DIRECT TESTIMONY AND EXHIBIT
OF
BRIAN HORII
ON BEHALF OF
THE SOUTH CAROLINA OFFICE OF REGULATORY STAFF
DOCKET NO. 2018-2-E
IN RE: ANNUAL REVIEW OF BASE RATES FOR FUEL COSTS FOR
SOUTH CAROLINA ELECTRIC & GAS COMPANY

Figure 1: SCE&G Estimate of Winter Peak Demand using Historical Weather (Exhibit JML-2, p. 4)

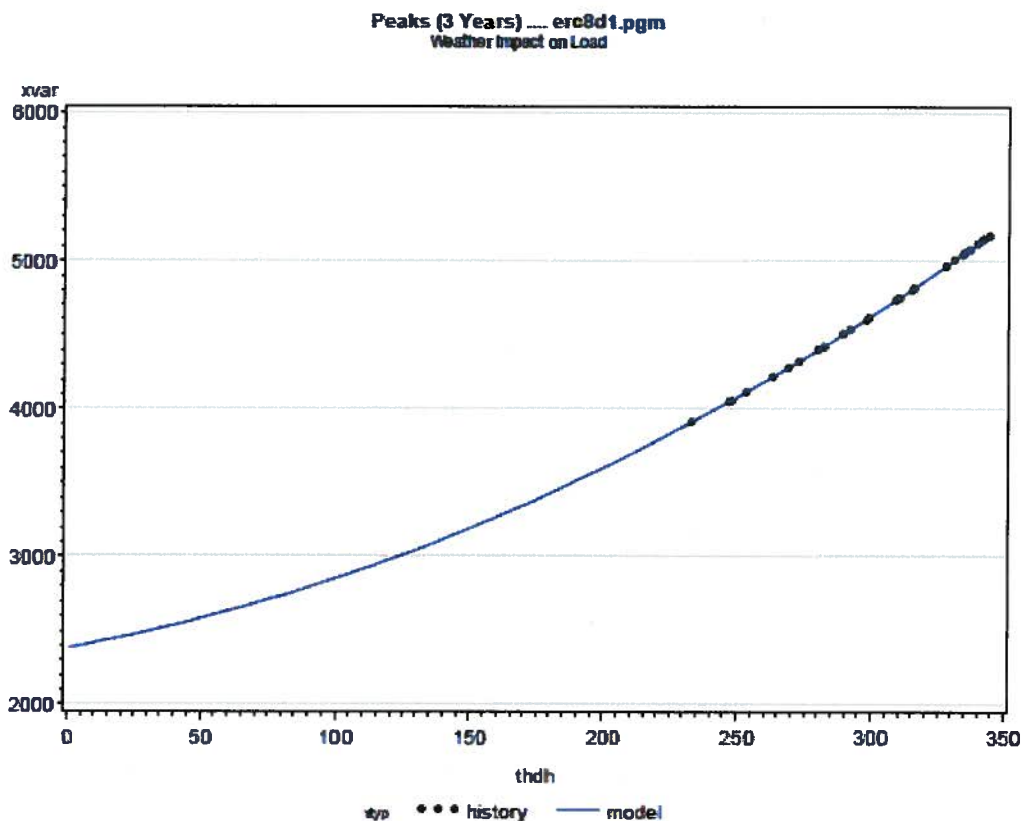
Note the shape of the regression line. It slopes upward at an increasing rate, so that it predicts that peak load will rise at an ever increasing rate as the days get colder. Contrast that to the shape of SCE&G's predicted peak loads in the summer. In the summer figure, reproduced below, the rate of increase declines as weather becomes more extreme. This is indicated by the slight downward curve of the regression results.

In contrast, the winter shape has an upward curve, which is counter to engineering-based expectations. This upward curve also exacerbates the variation in peak demand, compared to the downward curve of the summer predictions. This can result in an overly large estimate of winter variability for the winter season compared to the summer season.

13 Put another way, SCE&G created a model to estimate daily peak load for any day
14 in the winter. The response of customers to changes in hdh at moderate levels is likely not
15 the same as their response at higher hdh levels. This is probably why the SCE&G model
16 has the curved shape. It is trying to fit two different response shapes. By reducing the data
17 set to exclude those moderate hdh days, my model specification is not affected by the
18 moderate days, and the curved shape is rejected for my data set --- which shows that the
19 curved response shape is not fundamental to customer response at high hdh levels.

1 **A.** I estimate that SCE&G winter variability is 425 MW, as compared to SCE&G's
2 estimate of 542 MW. I estimated the variability using a corrected version of SCE&G's
3 regression data set. The most significant correction I made was to remove days that had
4 relative low temperatures. In the 27 years of historical winter peak data that SCE&G
5 provided, the lowest heating degree hour ("hdh") was 233. Hdh are the sum of the
6 difference between a day's hourly temperatures and a base temperature such as 60 degrees.
7 The colder the day, the larger the hdh. I, therefore, excluded all days with hdh at or below
8 200 from the dataset, as such moderate days would have little chance of being a peak winter
9 day. By doing this, the remaining data produced a regression model that gave a better
10 representation of peak electricity demand on winter peak days, and also revealed a more
11 logical linear relationship with hdh, rather than the quadratic relationship that SCE&G

Figure 2: SCE&G Estimate of Summer Peak Demand using Historical Weather (Exhibit JML-2, p. 4)

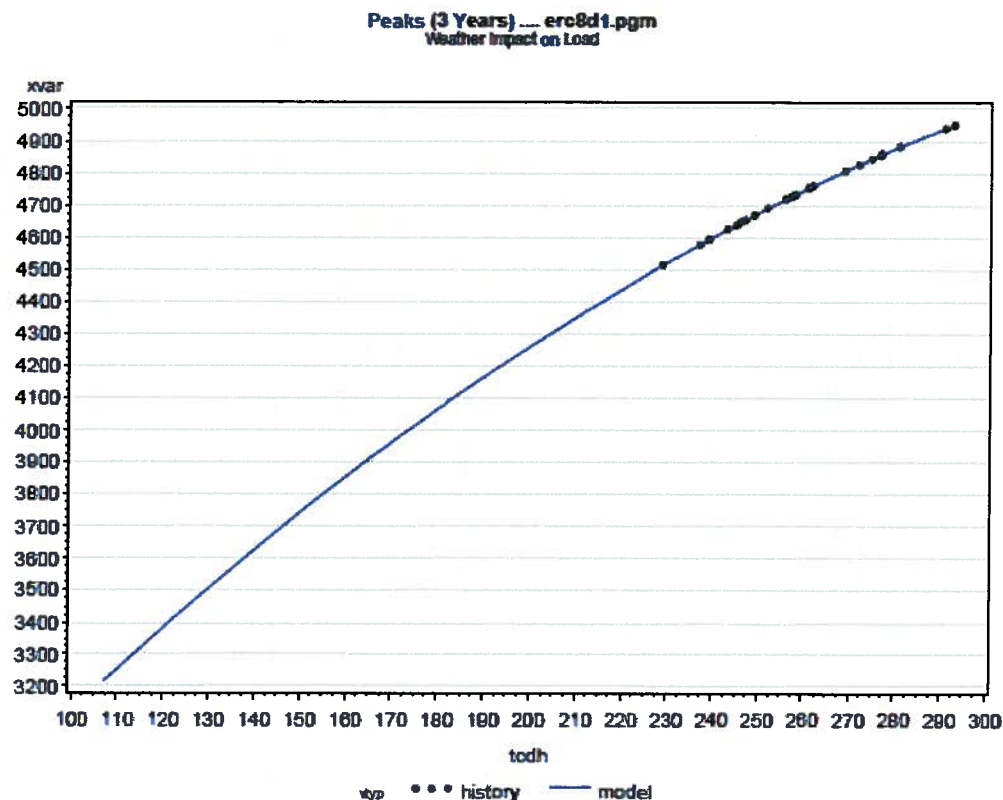
The summer shape is what I would expect. As weather becomes more extreme, the cooling equipment becomes more heavily used, but eventually top out and cannot increase electricity usage any further. As individual units top out, one sees diminishing increases in load as temperatures worsen.

Figure 3: E3 Modeled Winter Peak Demand using Historical Weather

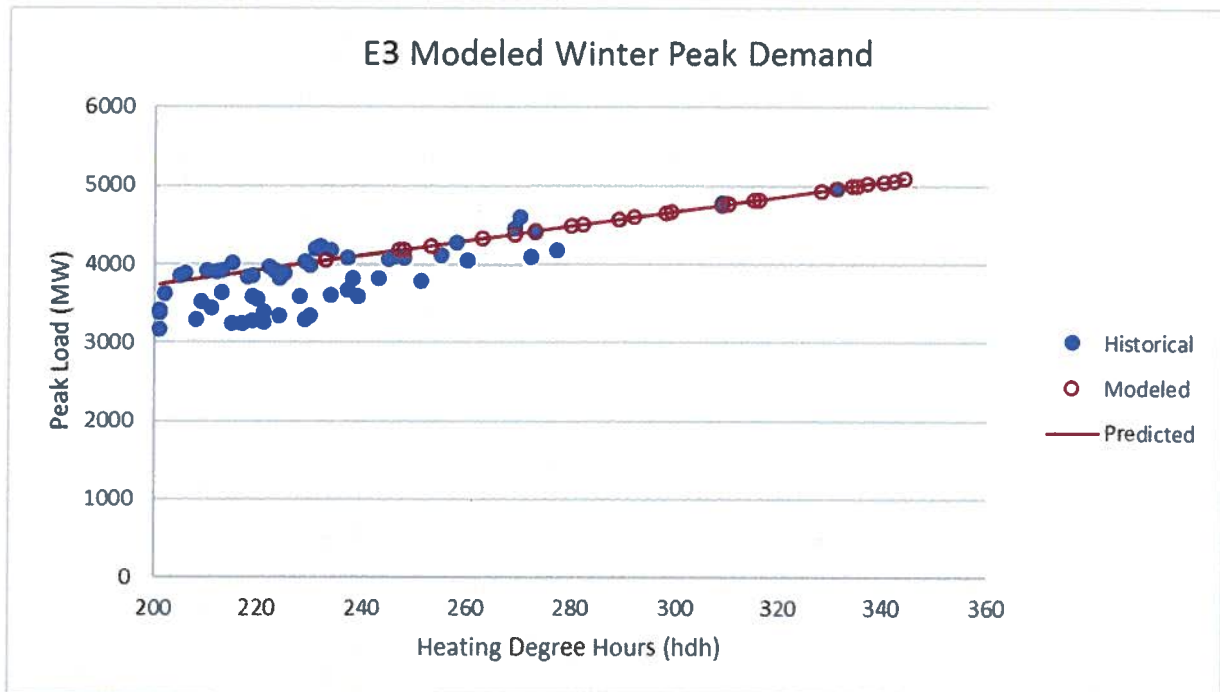
20 The figure below shows the historical data that I used in my analysis, as well as the
21 predicted peak loads based on hdh. The round circles are the predicted peak loads for 2016,
22 at the peak day hdh observed over the last 27 years. The predicted peak would vary by

month, so I have assumed January peaks for the figure. Note that the January assumption does not affect the calculation of winter demand-side risk.

SCE&G defined demand-side risk as the difference between the modeled maximum peak demand and average peak demand using the 27 years of peak hdh. The table below compares SCE&G's values used in their 2017 Reserve Margin study, and the results from my regression model. The lower deviation of 425 MW is the value used in my Reserve Margin calculation earlier in this testimony.
